4-09-013

Exhibit 13
4-09-013 (Mariposa)
Correspondence

Re: **Vegetation Restoration Plan for the Mariposa Land Property at Malibu
Creek City of Malibu, California**

Figure 1. Mariposa RipRap area on Malibu Creek, mapped June 22, 2009 by Heal the Bay and Baykeeper staff.

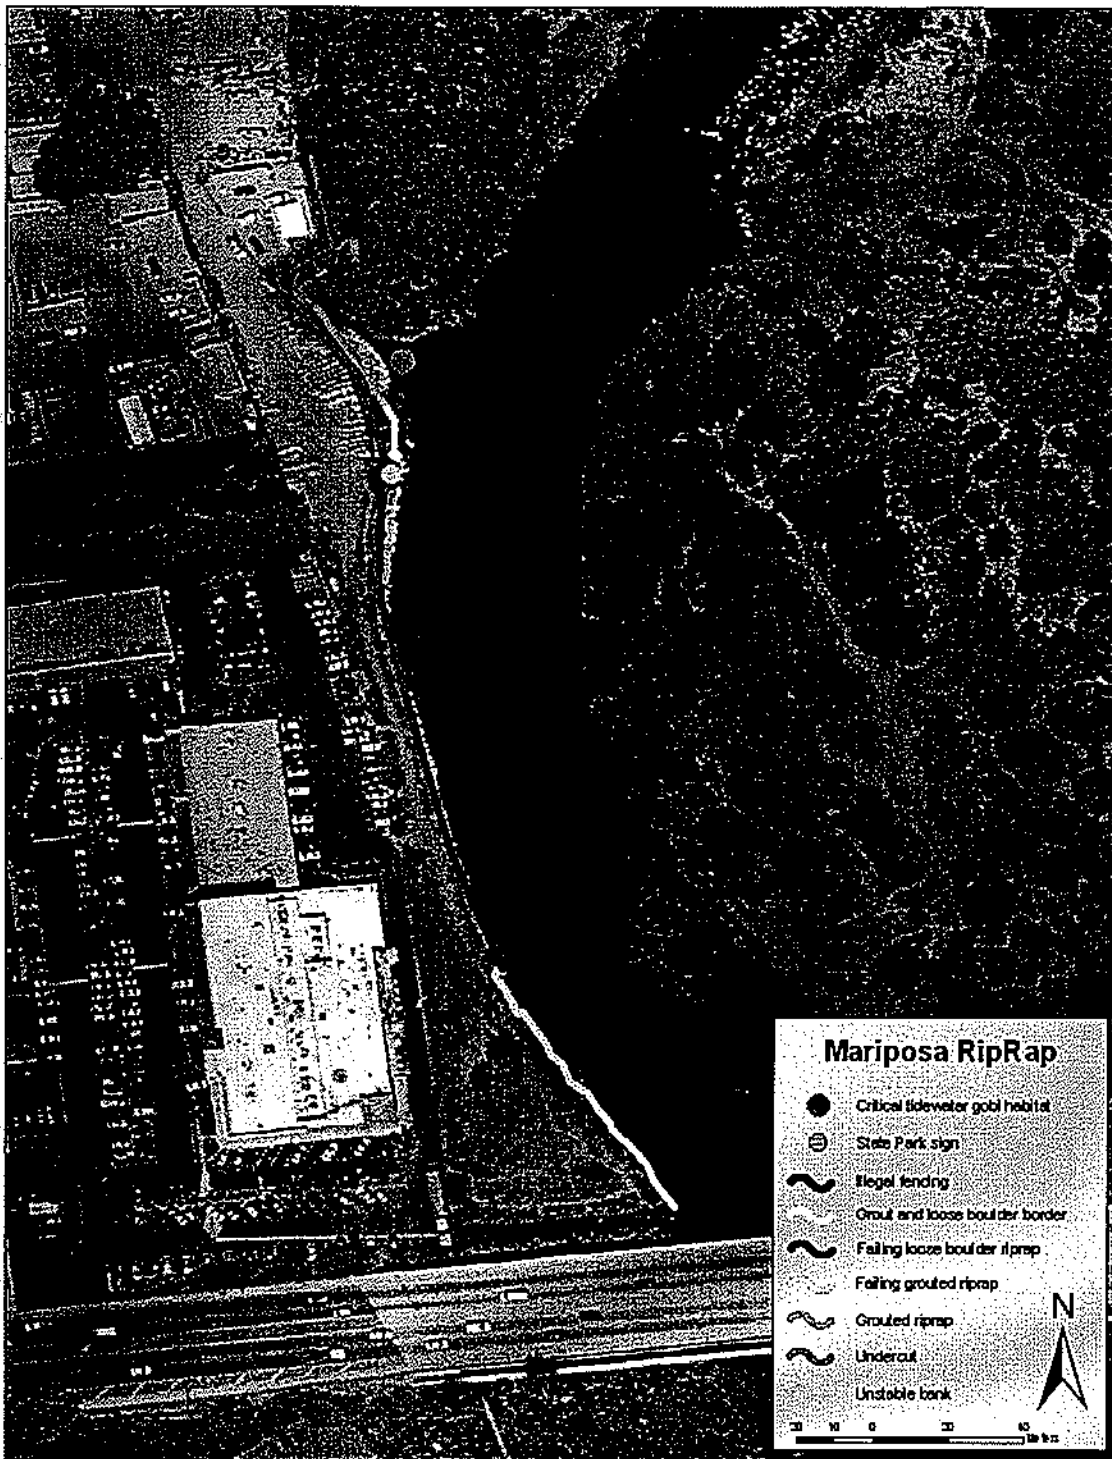
The results of our mapping efforts are attached as Figure 1, which clearly delineates the unpermitted development on the site (referenced in our April 6, 2009 letter to the Commission). Photos of this area are attached as Figures 7-11. Development within the fenced area is visible in Figures 8-11. A photograph of the large white trailer visible in the later aerial photos (Figures 5 & 6) clearly shows surrounding intensive development that includes a road (Figure 11). The illegally fenced area and all enclosed unpermitted structures and development were constructed post 1979, with most development having occurred between 1986 and 2004, as indicated in the attached aerial photos of the area from 1979, 1986, 2002, 2004, and 2008 (Figures 2-6). Black line polygons were added as a layer to these aerial photographs in order to clearly delineate the area of unpermitted construction. The polygons appear to be slightly different sizes due to the different angles from which aerial photos were taken; however, they delineate the same area on the ground.

In addition to mapping the described unpermitted developments, Heal the Bay mapped areas of failing riprap and unstable stream bank downstream from the riprap. Linear areas mapped in Figure 1 include grouted concrete and portions of failing grouted concrete that are within a fenced area marked with a State Park sign. Areas of failing grouted riprap are visible in Figure 12. Also included in Figure 1 is the linear area of loose boulder concrete placed by Mariposa Land Co. and the area of unstable stream bank downstream of all riprap areas. There are multiple failures along the entire length of loose boulder riprap; two of these loose boulder riprap failures are visible in Figures 13 and 14. Areas of undercut loose boulder riprap, which we measured to 1.3 m, are mapped in Figure 1, and are visible in Figure 15. The entire length of stream bank on the subject site and downstream from riprap areas is clearly eroded and unstable (Figure 16).

Illustration of Construction Methodology required to meet staff recommendation for Coffor Dam, dewatering removal, grading and replacement of rock.

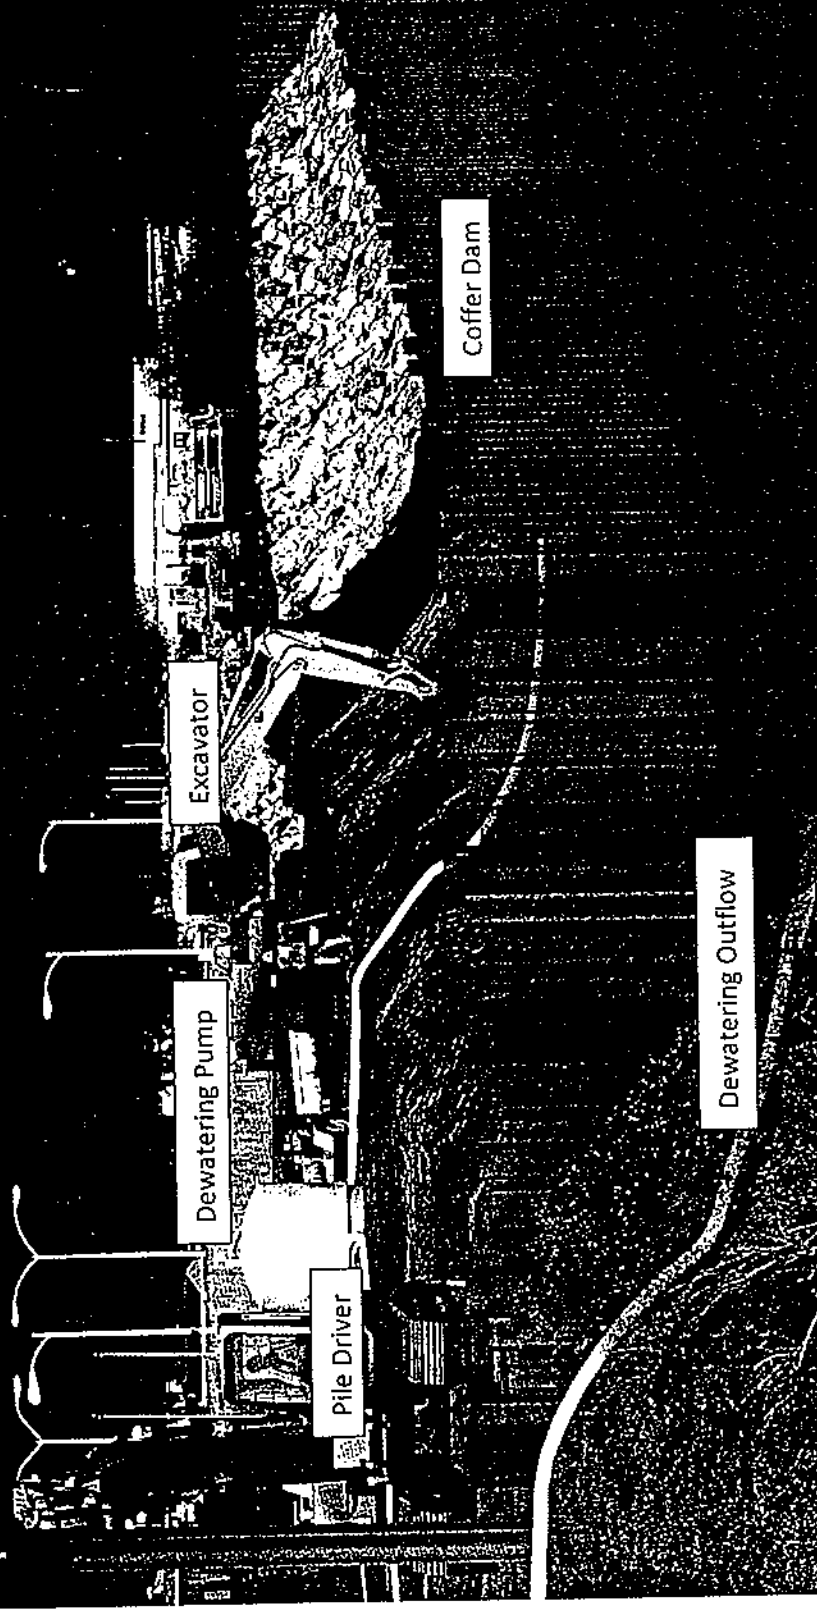
Once the rocks have been removed, large backhoes would grade back the bank to the Staff's desired 2 to 1 slope. Then a filter blanket would be laid over the bank and the rocks would be returned. In order to avoid damage to the filter blanket, placing the rocks is again more difficult than the original 1998 placement. Willow plantings through holes cut in the filter blanket would then be done as mitigation. The coffer dam would be removed. This is generally done by vibrating the piles to loosen the piles from embedding in the creek bottom. An illustration of the elements necessary to carry out the Staff Recommendation is included as Applicant's Exhibit, Tab 3, where the coffer dam, various heavy equipment and dewatering pumps are shown.
